BCA REPORT

Lot 202 Goonoo Goonoo Rd, Tamworth
(Tenancy 3 & 4)

Report No. BCA-25004-1 dated 05.02.2025

Figure 1 – Fire Wall Locations

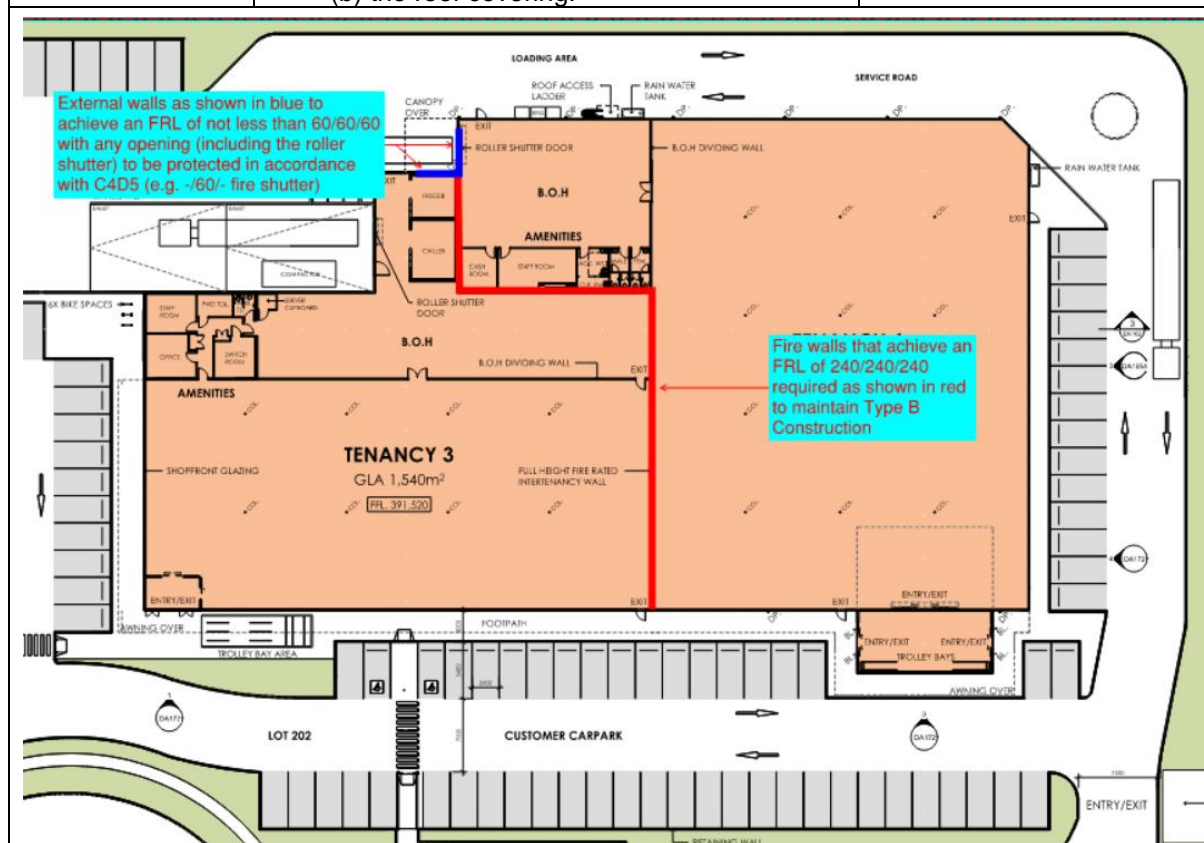
<p>(c) Building elements, other than roof battens with dimensions of 75 mm x 50 mm or less or sarking-type material, must not pass through or cross the fire wall unless the required fire-resisting performance of the fire wall is maintained.</p> <ul style="list-style-type: none"> Separation of fire compartments — A part of a building separated from the remainder of the building by a fire wall may be treated as a separate fire compartment if it is constructed in accordance with (a) and the fire wall extends to the underside of: <ul style="list-style-type: none"> (a) a floor having an FRL required for a fire wall; or (b) the roof covering. 	with the CC application demonstrating compliance.
--	--	---
